Serial No. 09/917,722

Docket No. P-0247

Reply to Office Action mailed December 28, 2004

**AMENDMENTS TO THE DRAWINGS:**

FIG. 1  
BACKGROUND ART  
PRIOR ART

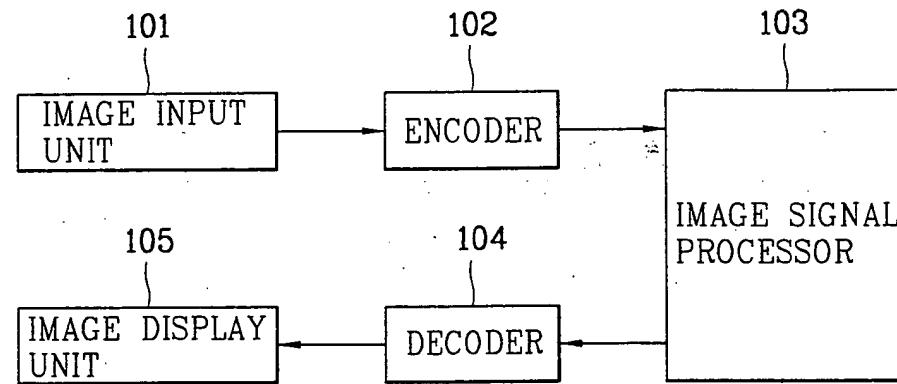
The Office Action states Figure 1 should be labeled as --Prior Art--. However, there is no indication of why Figure 1 is "prior art." That is, Figure 1 is properly labeled as --Background Art--. Applicants respectfully disagree with the Office Action's requirement. However, applicants have amended Figure 1 as suggested in the Office Action so as to further prosecution. This is not an admission as to Figure 1 being prior art.

The attached annotated sheets show changes to Figs. 1, 3 and 4. For example, Fig. 1 is amended to change “Background Art” to --Prior Art--. In Fig. 3, the outputs of block S12 have been reversed and in Fig. 4, the outputs of block S21 have been reversed. These changes are based on the specific discussion set forth in the specification.
